**ADDENDUM NO. 1
TO
PLANS AND SPECIFICATIONS
FOR
PROJECT NO. ENG200372291**

DESCRIPTION OF PROJECT: Double Vault Toilet Installation Improvements 2021

LOCATION: Brown County State Park

INDIANA STATE AGENCY: DEPARTMENT OF NATURAL RESOURCES

Site # 8 - Recreation Building.

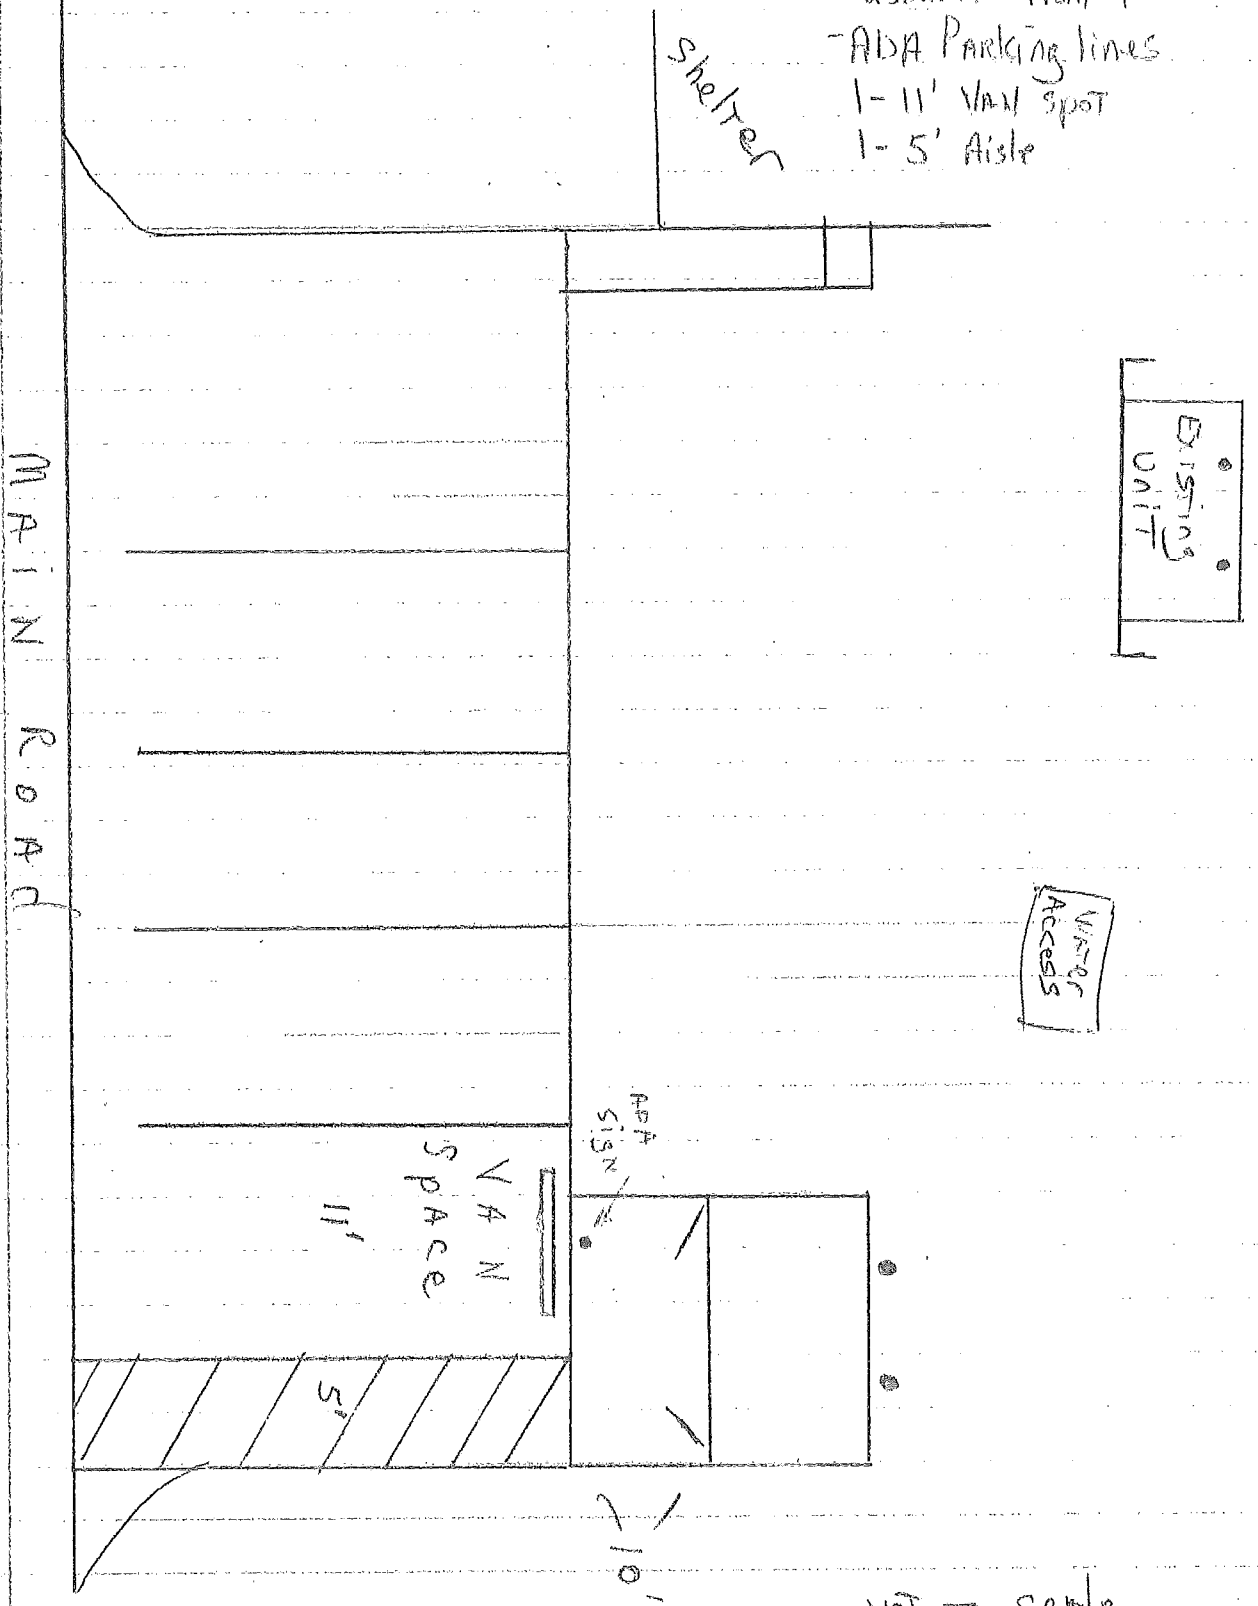
- Demo old unit
- grass finish grade.
- Finish floor 3" above
asphalt - front &
- ADA Parking lines
1- 11' VAN spot
1- 5' Aisle

Site # 9 - Rally Camp

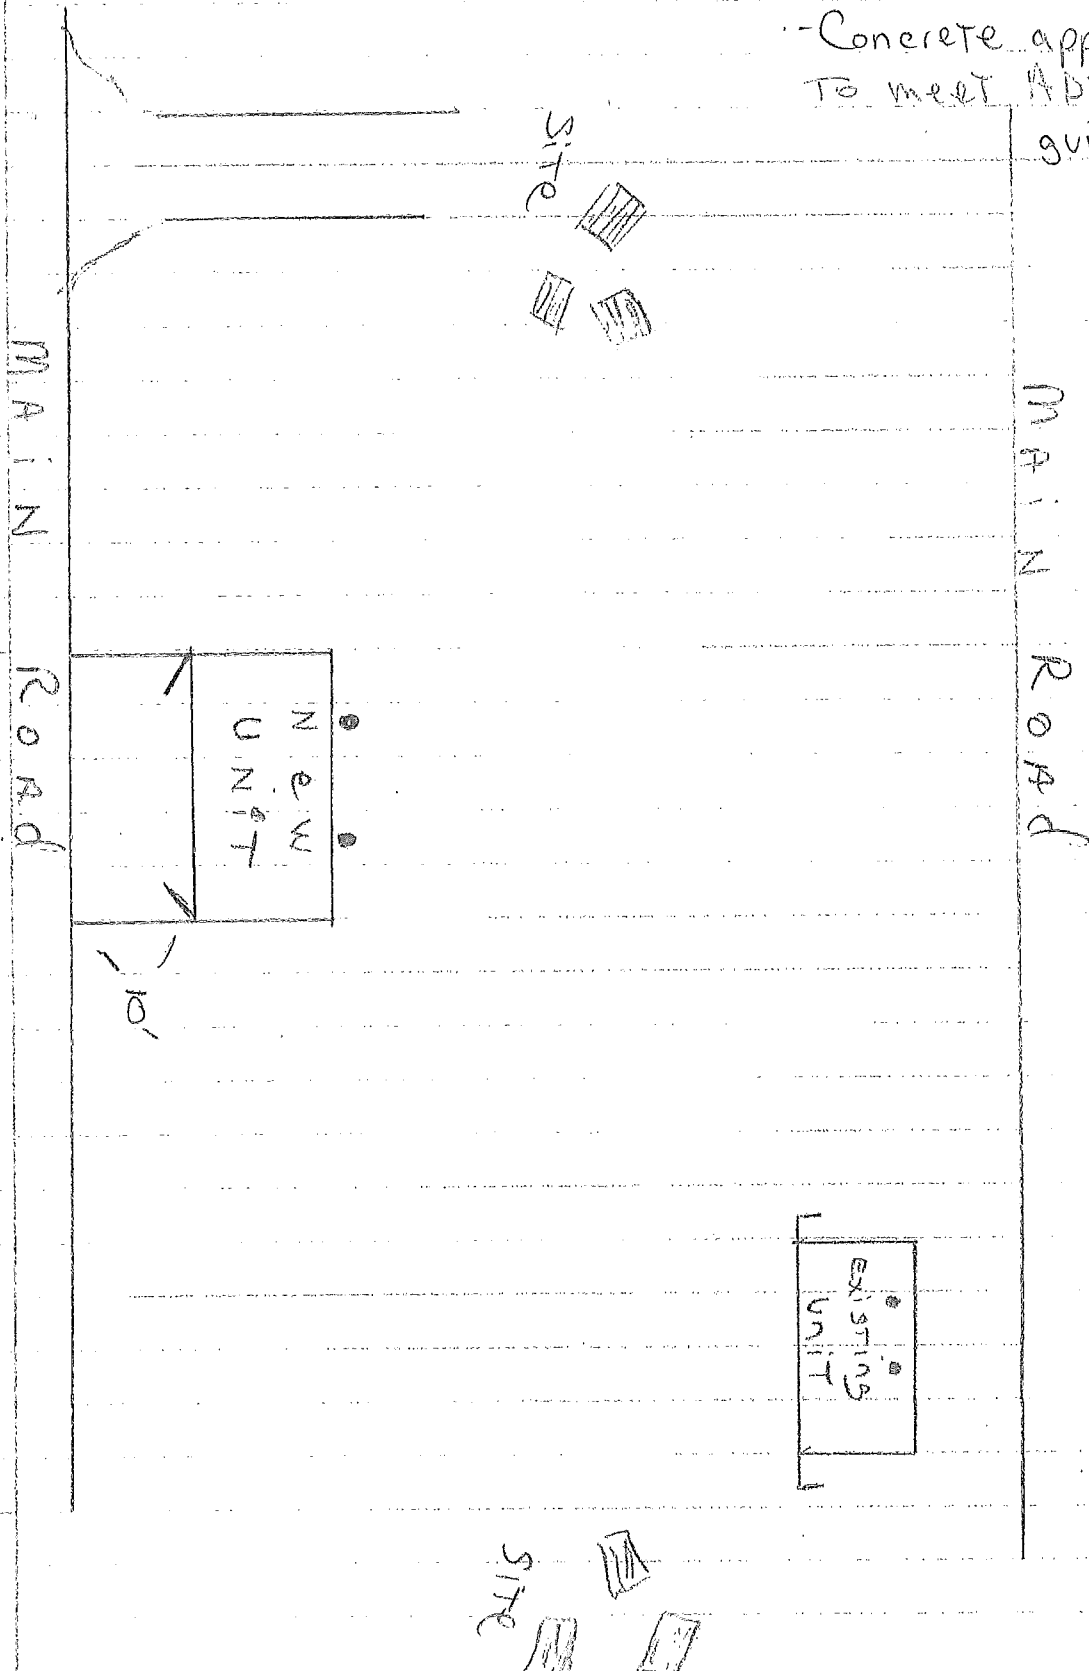
- Demo old unit
- grass finish grade
- finish Floor 3" above asphalt & front @ road.
- Concrete approach to meet ADA slope% guidelines.

Site # 10 - Fire Tower

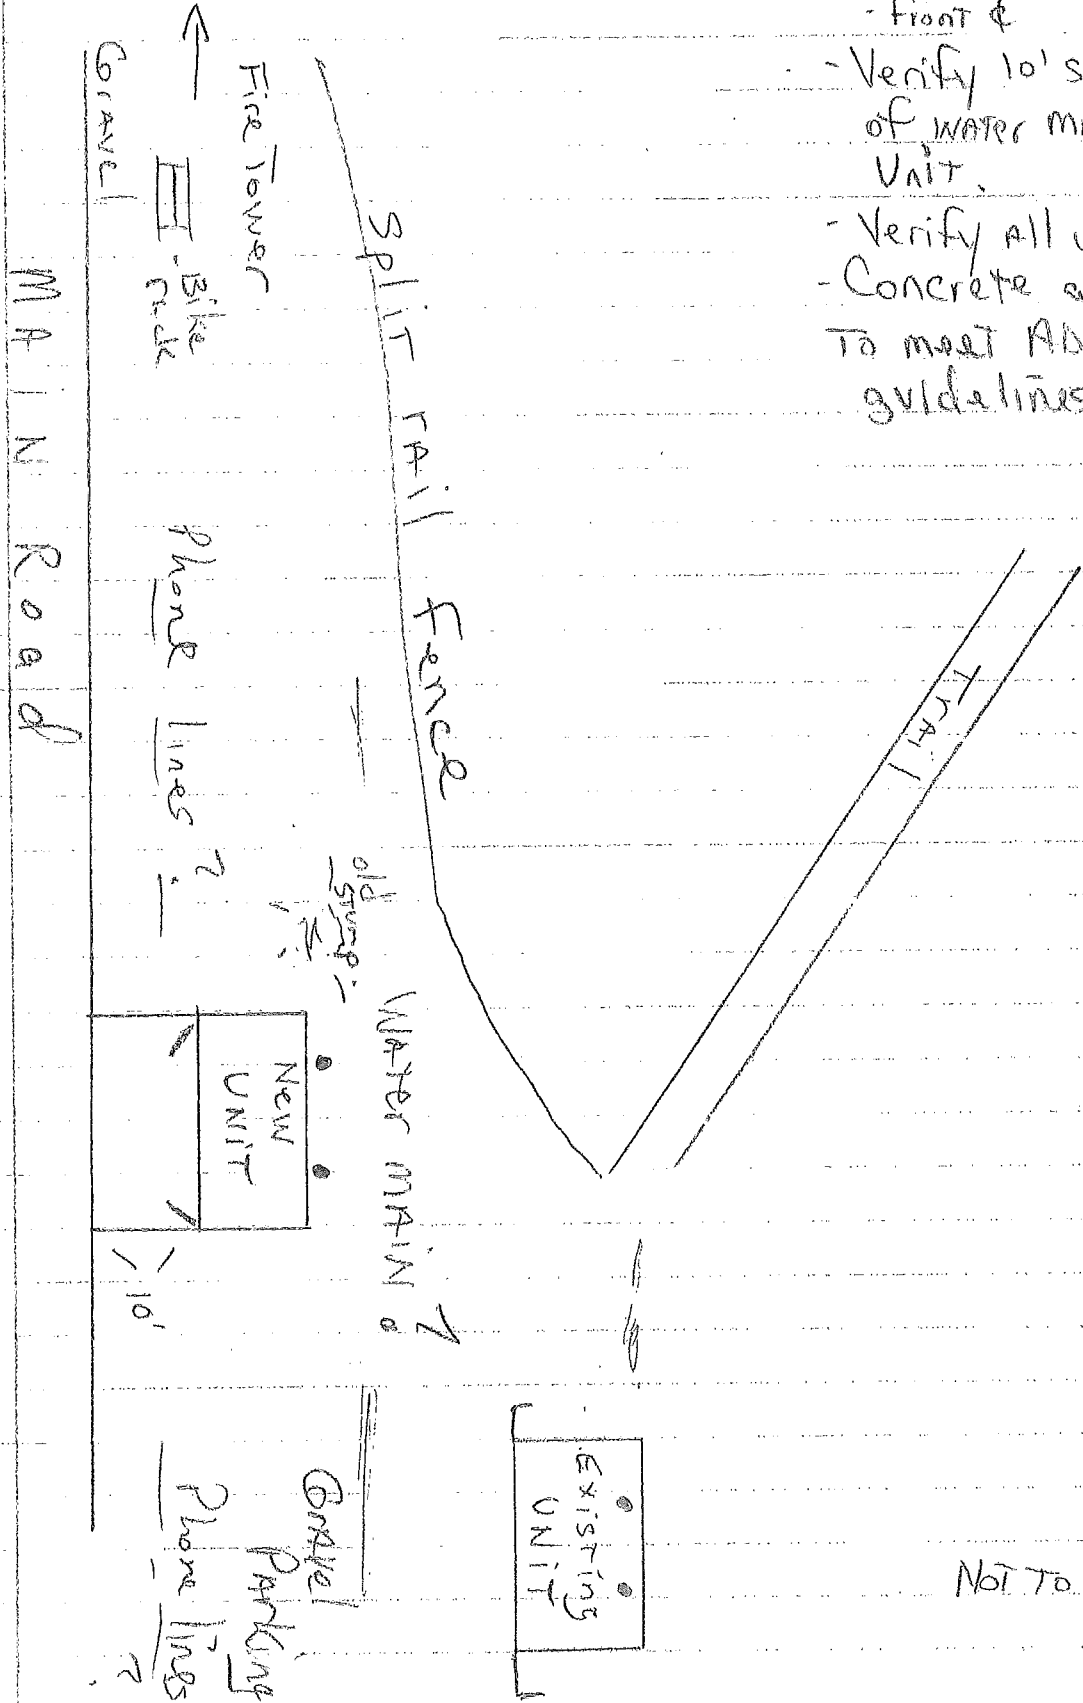
- Demo old Unit
- grass finish grade
- Finish floor 3" above asphalt surface
- front &
- Verify 10' separation of water main to Unit.
- Verify all utilities.
- Concrete approach to meet ADA slope % guidelines

Site # 11 - Walnut Shelter

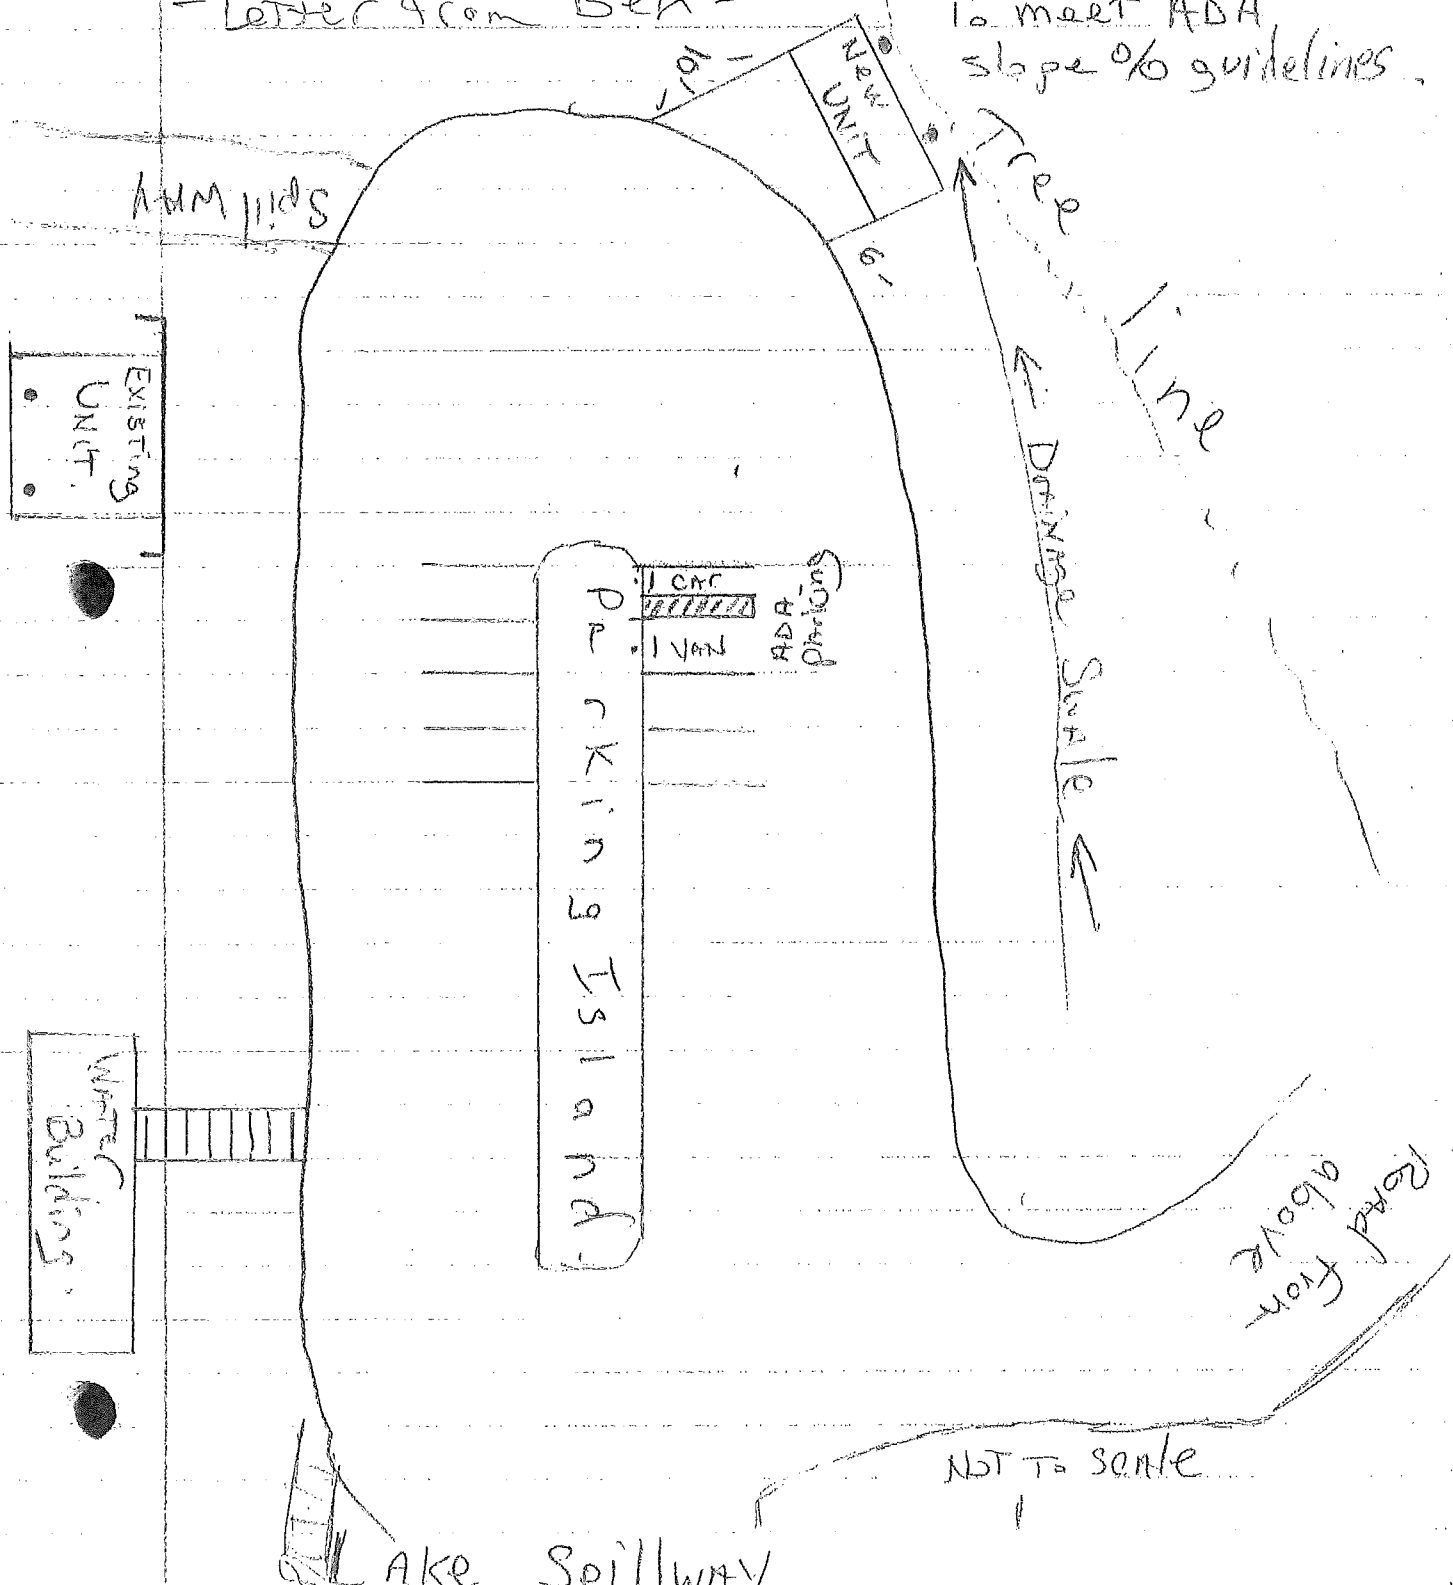
- Finish Floor 3" above gravel surface
- Front &
- Concrete approach to meet ADA slope % guidelines

* ADA Parking Striping/Signage - VAN + Aisle + CAR: 11' - 5' - 8'

Site # 12 - Ogle Lake

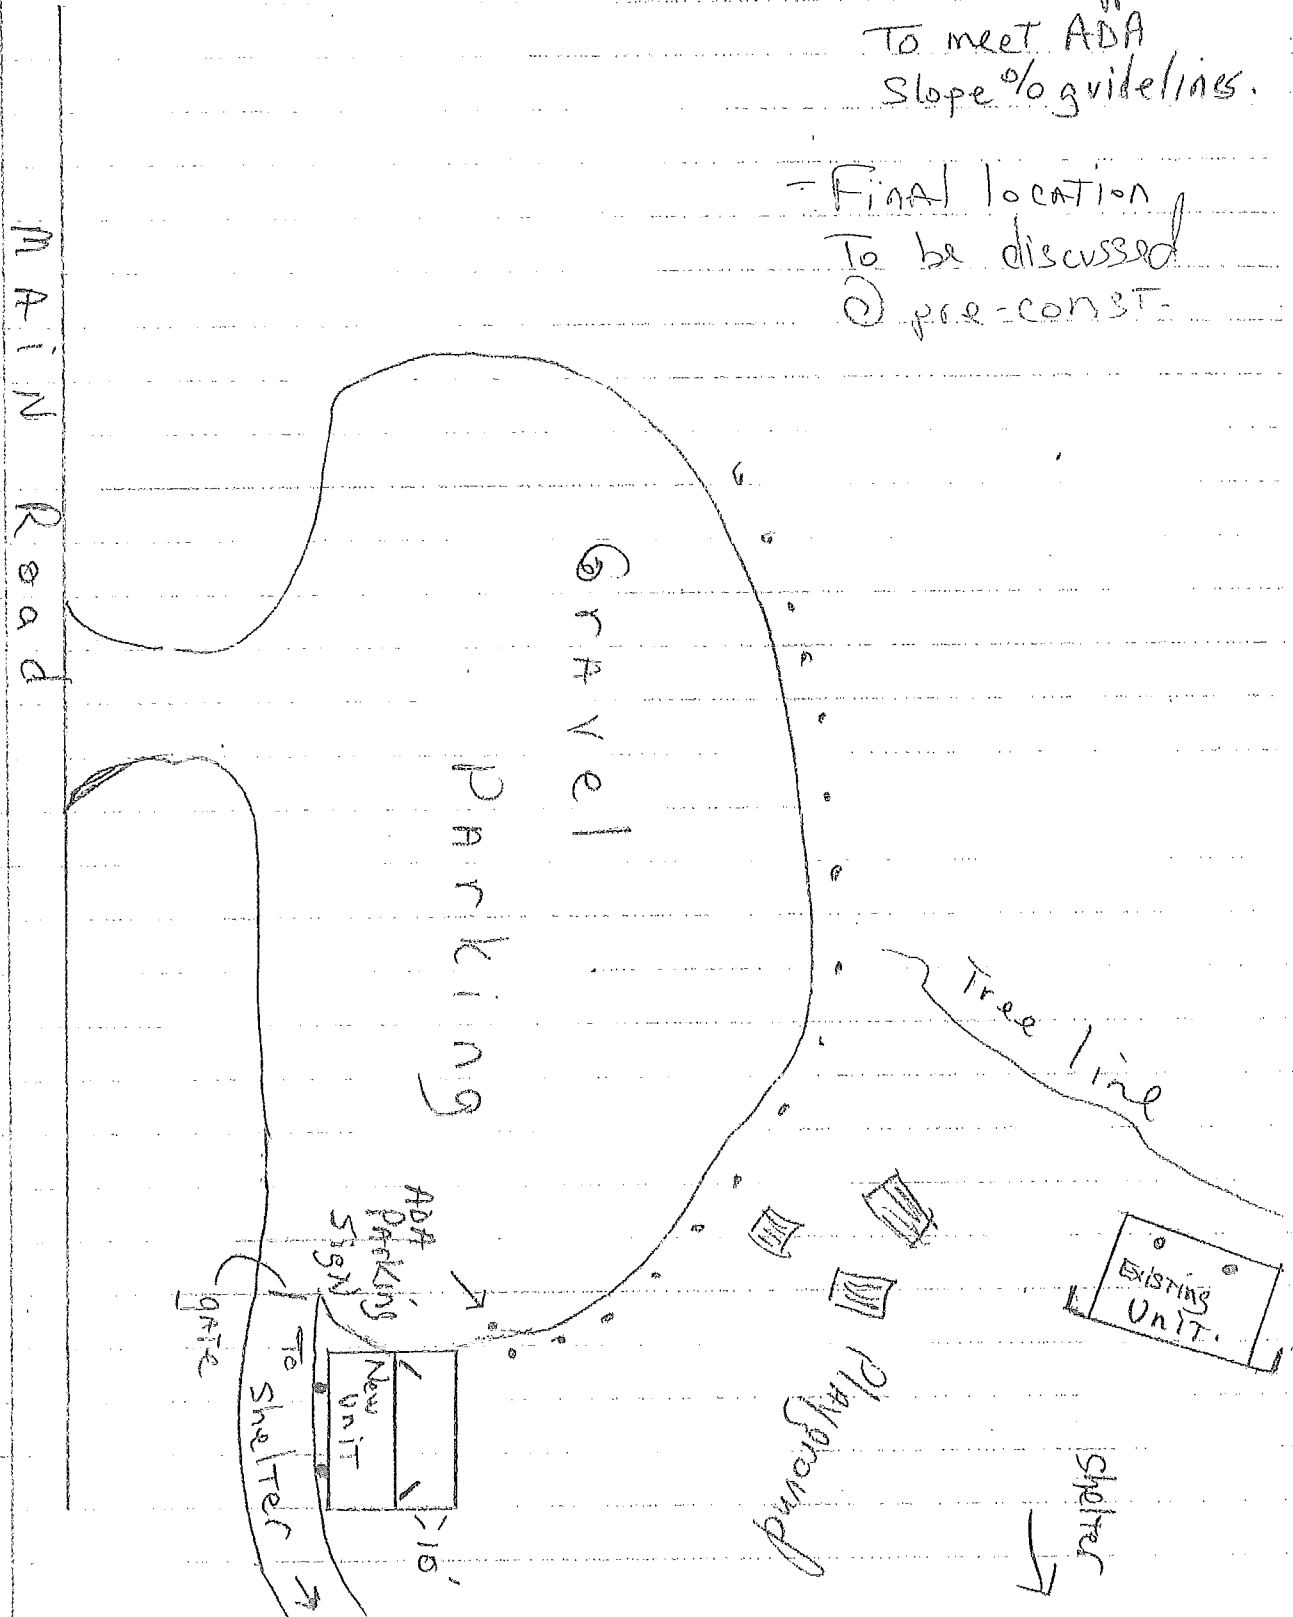
- Demo old unit
- grass finish grade
- Finish floor 3' above asphalt surface
- front +
- Concrete approach to meet ADA slope % guidelines.
